POLICY REPORT DEVELOPMENT AND BUILDING

TO: Vancouver City Council
FROM: Director of Planning
SUBJECT: CD-1 Text Amendment: 1700 Manitoba Street

1700 Manitoba Street
Form of Development

Ground Floor Plan

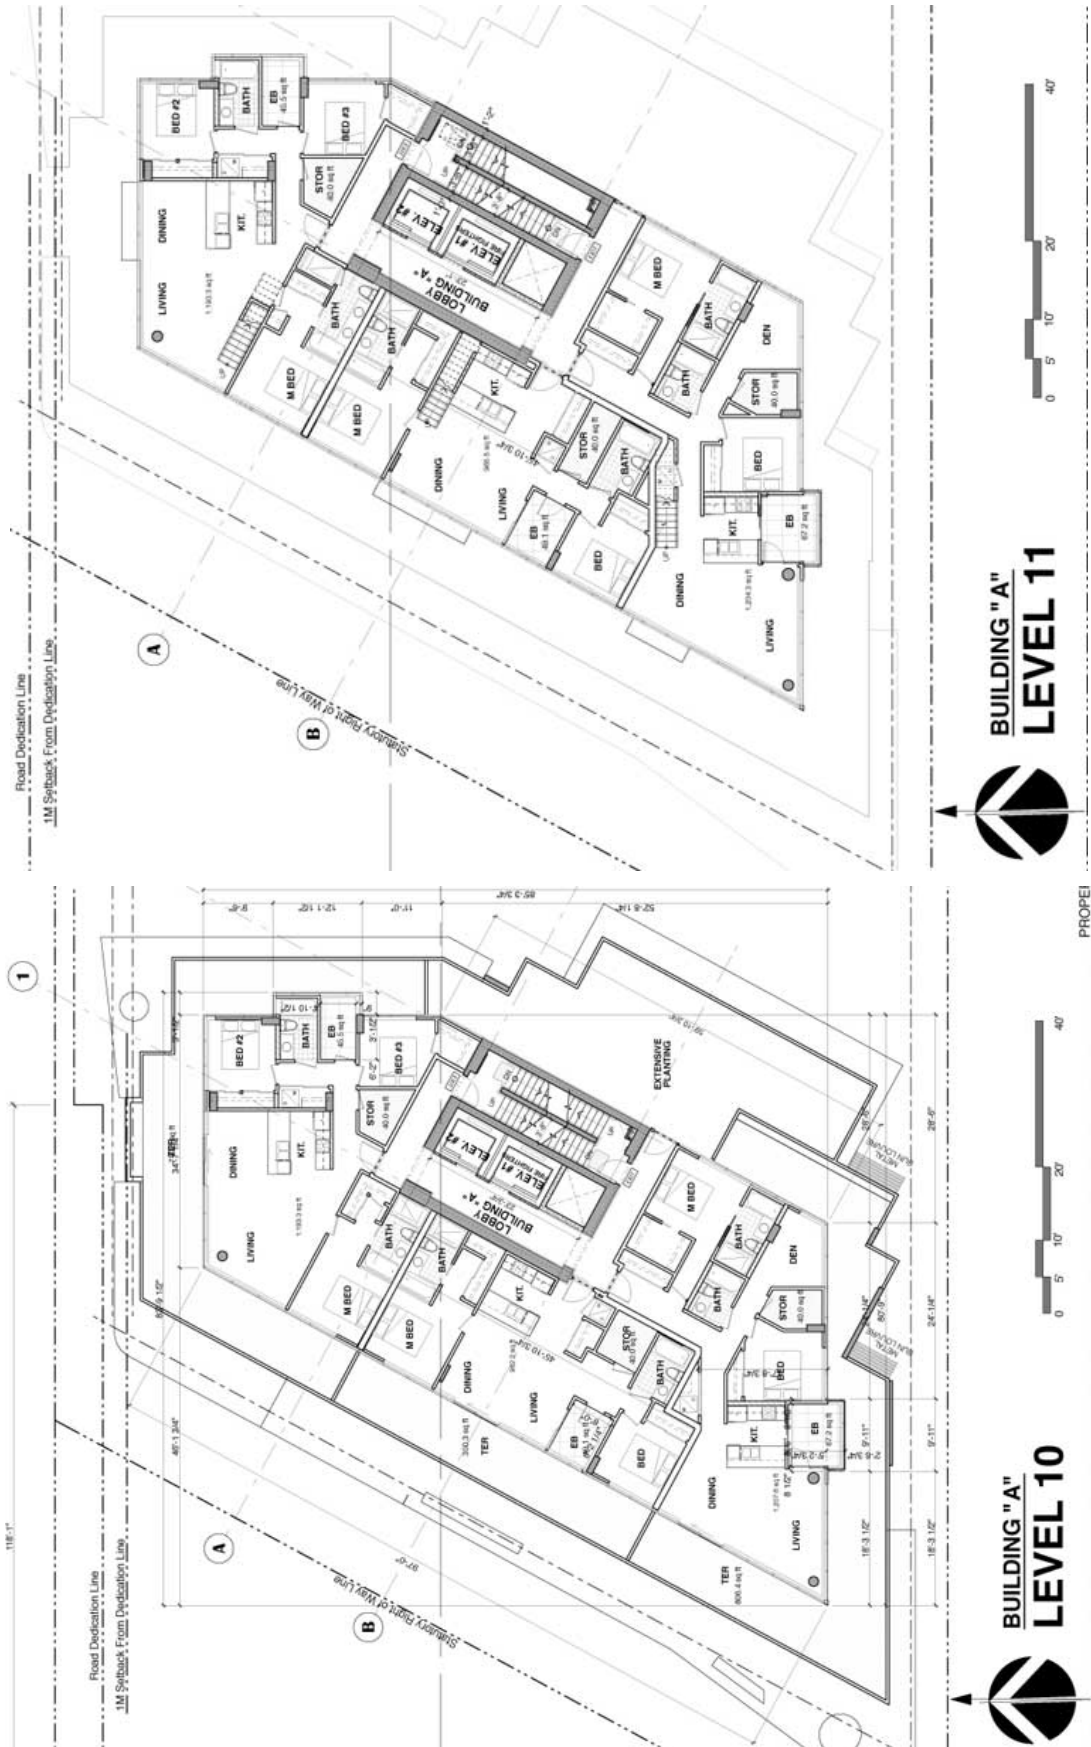
- (a) better integration of the swimming pool with the terminus of the ground-level breezeway and its relationship with the lane edge.

Note to Applicant: The pedestrian connection, from the street between the mid-rise and east tower (Building's 'B' and 'C'), ends abruptly with no logical termination. Reconcile various elements at the ground plane to improve the spatial flow.

- (b) address the height, scale, material treatment and blank expression of the lower wall at the lane edge.

Note to Applicant: The building edges adjacent to the lane need to be softened and humanized in scale for an enhanced pedestrian experience.

East Tower - penthouse levels

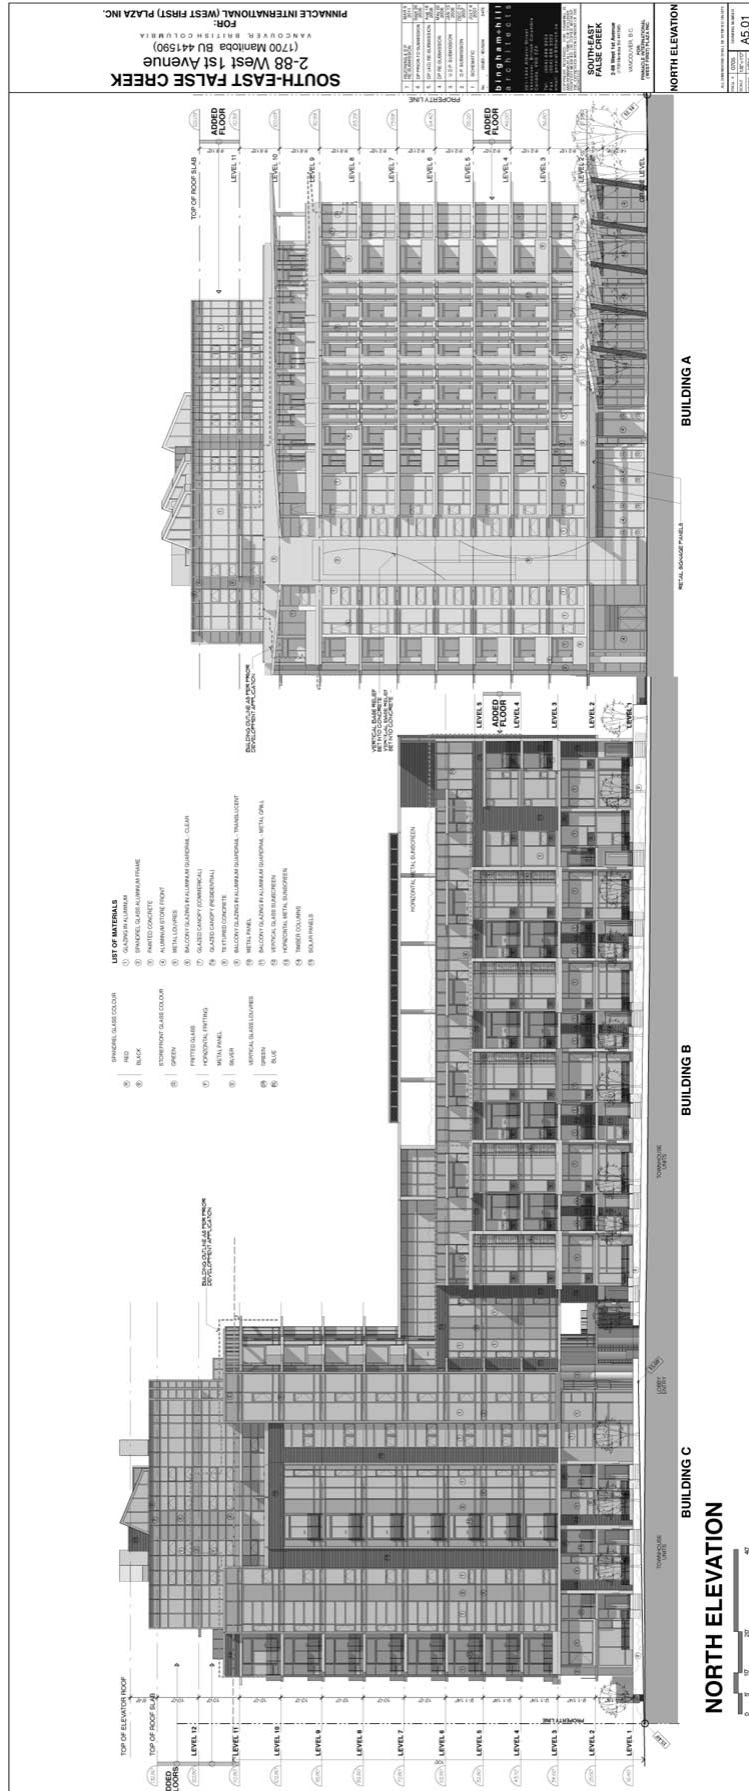
- (b) stronger definition between floors 10 and 11, north elevation, east tower (Building 'C').

Note to Applicant: A more distinctive break, emphasized with material changes to better delineate the shift to the partial floors of the upper massing is advised.
